Access Compliance Report Public Rights-of-Way (Curb Ramps)

Main Street: RED_HILL_AVE		Cross Street: BULLARD_RD		Location:	NW
ADA ID: RPRK211014175456	Ramp Type: Type 4 - Parallel	Initial Pass/Fail: Fail	Overall Compliance: No	Severity Score:	2
Codes/Mitigation Info/Possible Solution			Field Measurements/Component Compliance

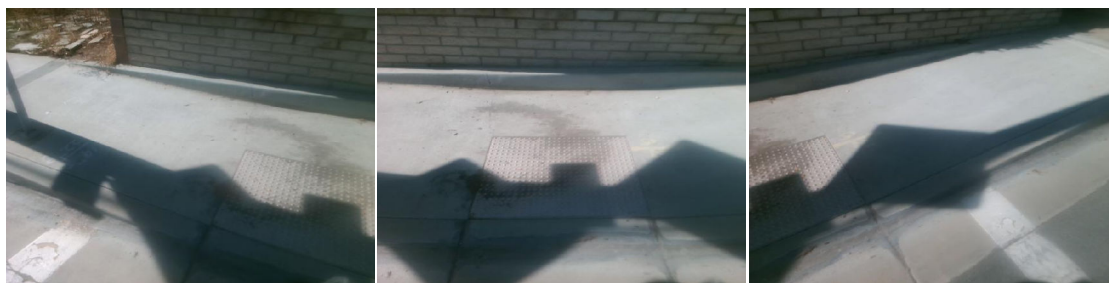
R204.3, R304.5.3, STD 1115

Remove & Replace Entire Ramp.
